**SUMMARY OF CHANGES
APPLICATION OF SELECTION CRITERIA TO THE DONALD C. COOK
NUCLEAR PLANT UNITS 1 AND 2 TECHNICAL SPECIFICATIONS**

**APPLICATION OF SELECTION CRITERIA
TO THE
DONALD C. COOK NUCLEAR PLANT
UNITS 1 AND 2
TECHNICAL SPECIFICATIONS**

Revision 1

FIGURE 3.1-2 Moderator Temperature Coefficient (MTC)

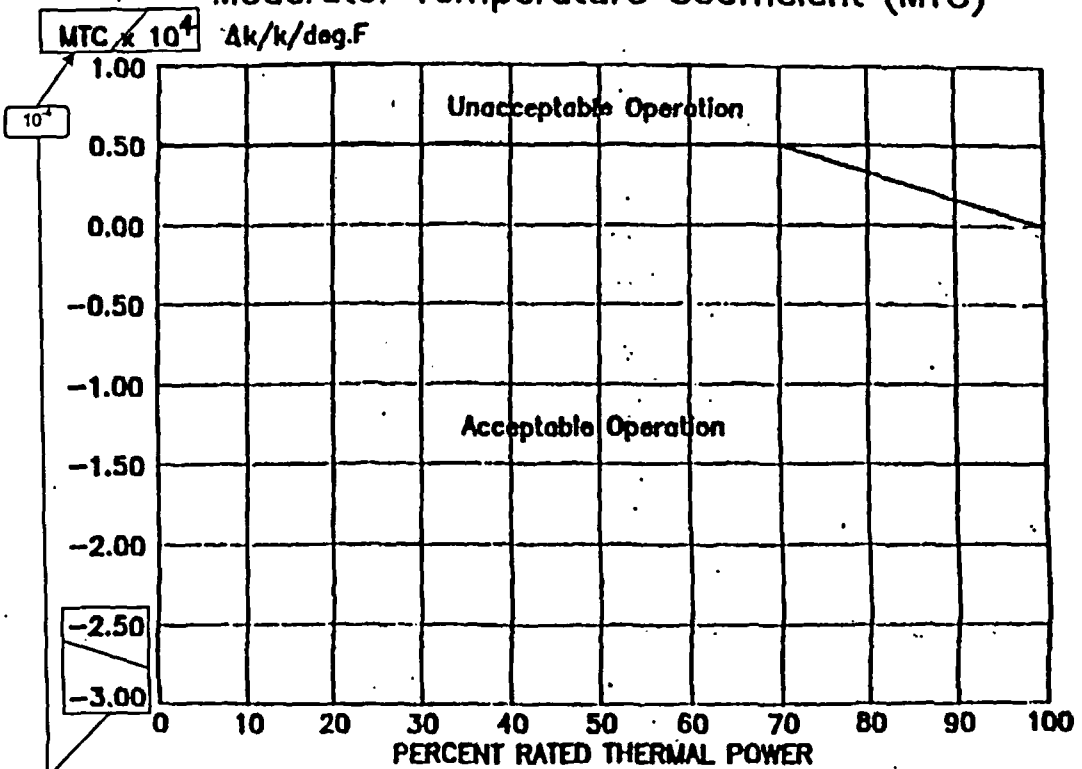
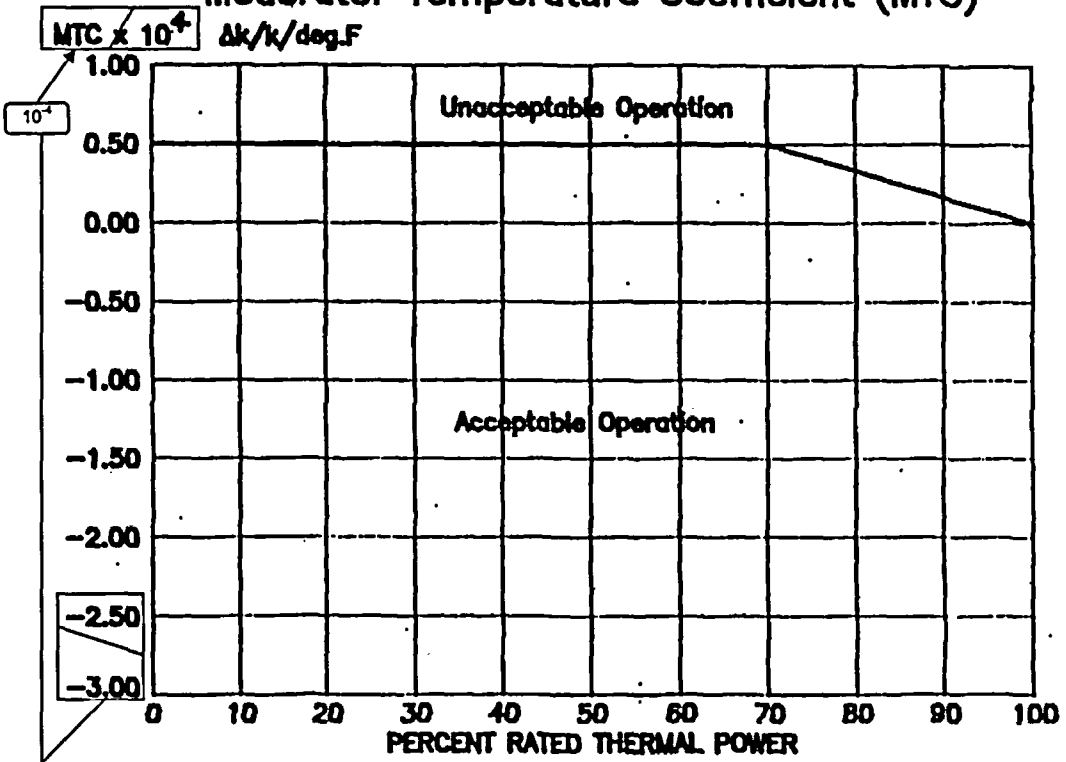
- A.6 CTS Figure 3.1-2 provides the maximum upper limit for MTC from 0% to 100% RATED THERMAL POWER (RTP). The Figure indicates that the value for MTC can vary from -3.00 to $1.00 \times 10^4 \Delta k/k/^\circ F$. ITS Figure 3.1.3-1 includes the same curve however the range has changed to -2.00 to $1.00 \times 10^4 \Delta k/k/^\circ F$. This changes the CTS by using the correct exponential (10^4 in the CTS to 10^{-4} in the ITS) and changing the range for MTC.

FIGURE 3.1-4

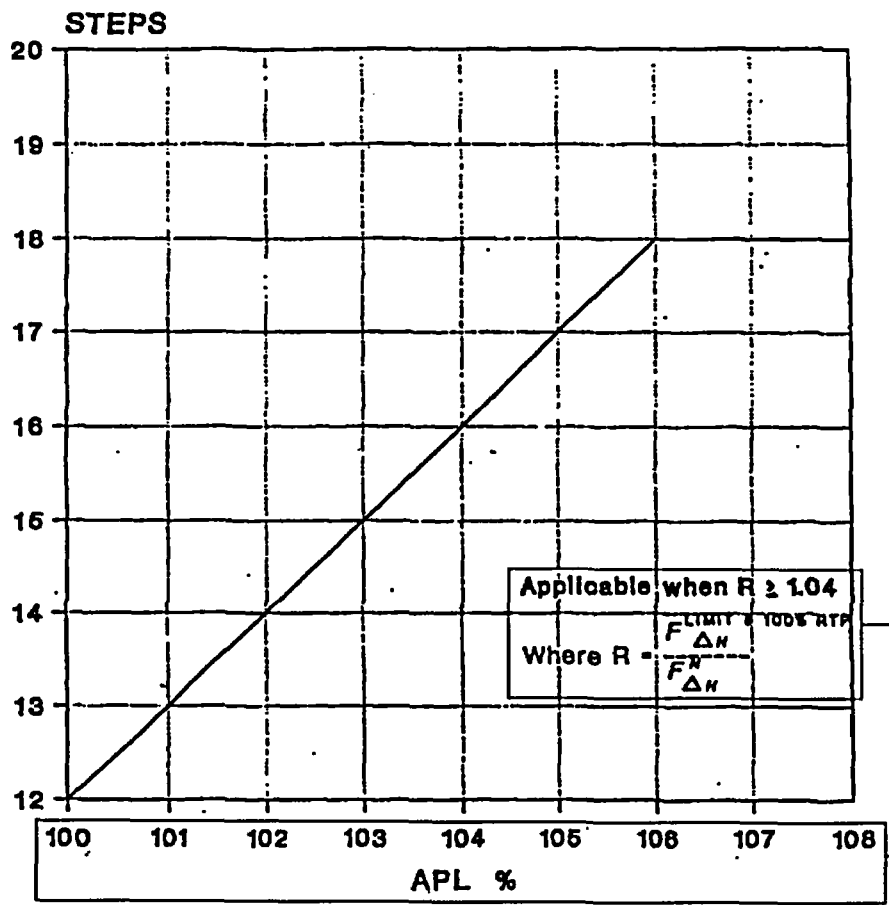
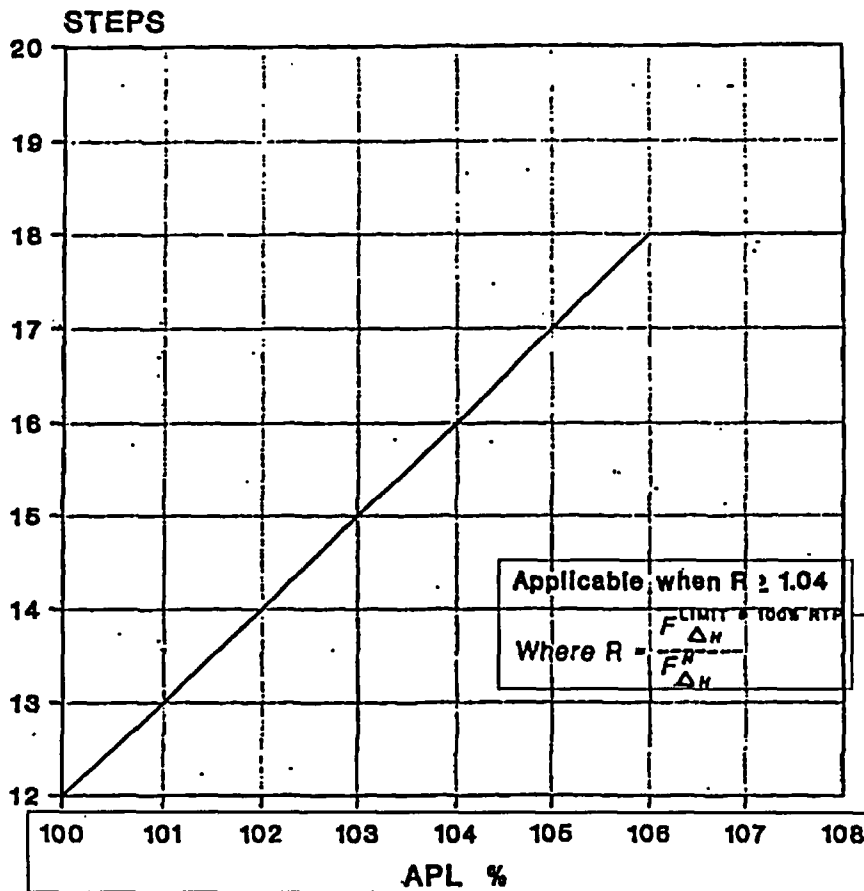
- A.2 CTS 3.1.3.1 specifies the rod misalignment limits for full length (shutdown and control) rods at a THERMAL POWER > 85% RATED THERMAL POWER (RTP) and at THERMAL POWER \leq 85% RTP. At a THERMAL POWER > 85% RTP the allowed rod misalignment is +/- 12 steps or as determined from Figure 3.1-4. In addition, CTS 3.1.3.1 states that Figure 3.1-4 permits an allowed rod misalignment from +/- 13 steps (for ALLOWABLE POWER LEVEL (APL) equal to 101%) to +/- 18 steps (for APL greater or equal to 106%) provided the value of R (defined in Figure 3.1-4) is ≥ 1.04 . The R limit and definition are maintained in the ITS 3.1.4 Note and the range of rod misalignment allowed is maintained in ITS Figure 3.1.4-1. ITS LCO 3.1.4 states that with THERMAL POWER > 85% RTP, the individual rod positions shall be within 12 steps of their group step counter demand position or as determined from Figure 3.1.4-1, and the Note to ITS LCO 3.1.4 states the R limit and provides the definition. ITS LCO 3.1.4 does not contain the allowed misalignment range and ITS Figure 3.1.4-1 does not include the R limit or definition.

- A.6 CTS Figure 3.1-4, Allowed Rod Misalignment above 85% RTP, is based upon the current Allowable Power Level (APL) as determined in CTS 3.2.6. In addition, CTS 4.1.3.1.3 requires the allowed rod misalignment for THERMAL POWER > 85% RTP to be determined in conjunction with the measurement of APL as defined in CTS 4.2.6.2. The term APL has been changed to $F_{\alpha}^W(Z)$, as described in the DOCs for ITS 3.2.1. Therefore, in the ITS, the allowed rod misalignment is being based upon $F_{\alpha}^W(Z)$. In order to maintain a similar value in the ITS Figure as is in the CTS Figure, the term in ITS Figure 3.1.4-1 is $(CFQ \times K(Z))/F_{\alpha}^W(Z)$. In addition, the ITS does not include a specific SR in ITS 3.1.4 to calculate the new allowed rod misalignment every time an $F_{\alpha}^W(Z)$ determination is made. This changes the CTS by using the term $F_{\alpha}^W(Z)$ in lieu of the term APL, and not including a specific SR to calculate the allowed rod misalignment every time $F_{\alpha}^W(Z)$ is determined.

The purpose of the details of CTS 3.1.3.1 is to clarify the details provided in the CTS Figure. However, the information provided in the two locations is duplicative. This change is acceptable because the technical requirements have not changed. The R limit and definition are maintained in the ITS 3.1.4 Note and the range of rod misalignment allowed is maintained in ITS Figure 3.1.4-1. Since the details are duplicative there is no reason to maintain the information in both locations. This change is designated as administrative because it does not result in technical changes to the CTS.

This change is acceptable since, as described in the DOCs for ITS 3.2.1, the term $F_{\alpha}^W(Z)$ is analogous to APL. Also, the specific SR is not needed because each time the $F_{\alpha}^W(Z)$ Surveillance is performed in ITS 3.2.1, the allowed rod alignment limit (if using ITS Figure 3.1.4-1) must be established based on the

$F_o(Z)$ ~~CAQC-W(Z) Methodology~~
B 3.2.1C

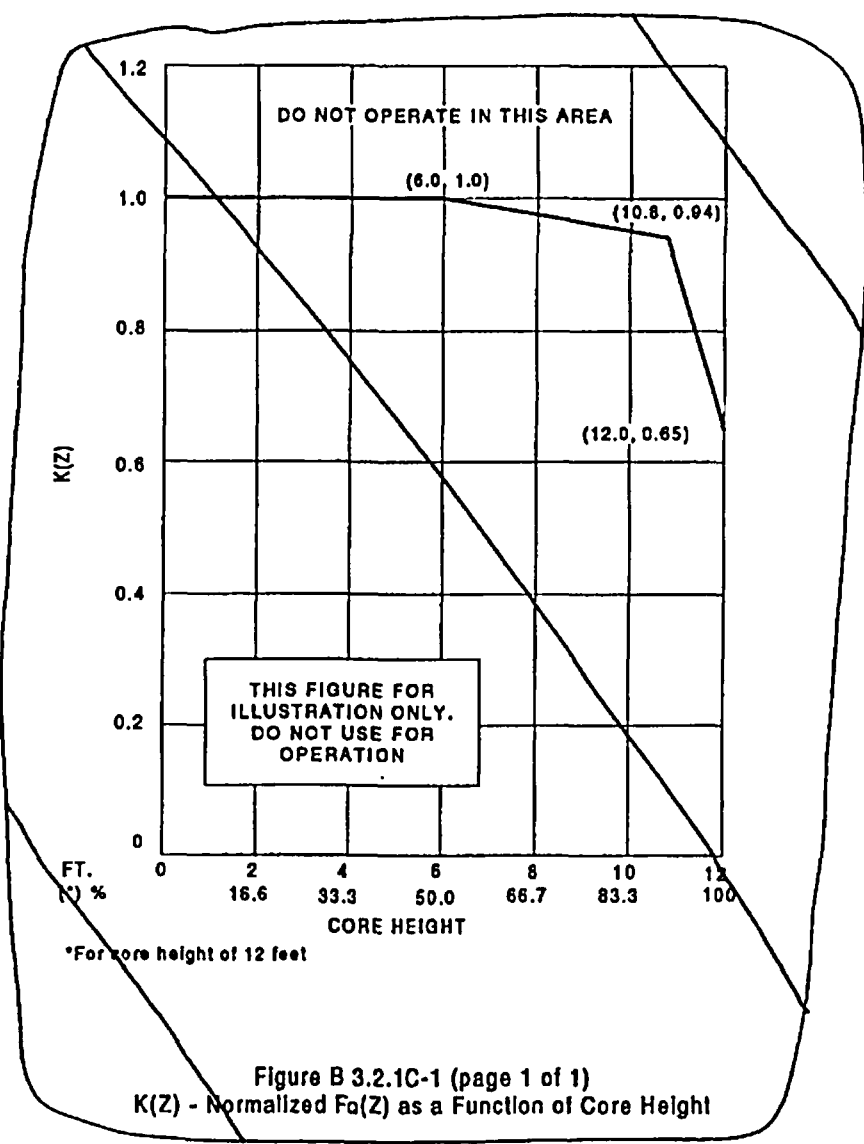
5. This generic statement is not necessary. The LCO Section of the Bases already states that certain values are specified in the COLR, and providing a "normal" value or Figure that is not the actual one in the COLR can lead to confusion that results in improper limits being applied. Therefore, the statement and the Figure B 3.2.1C-1 have been deleted.
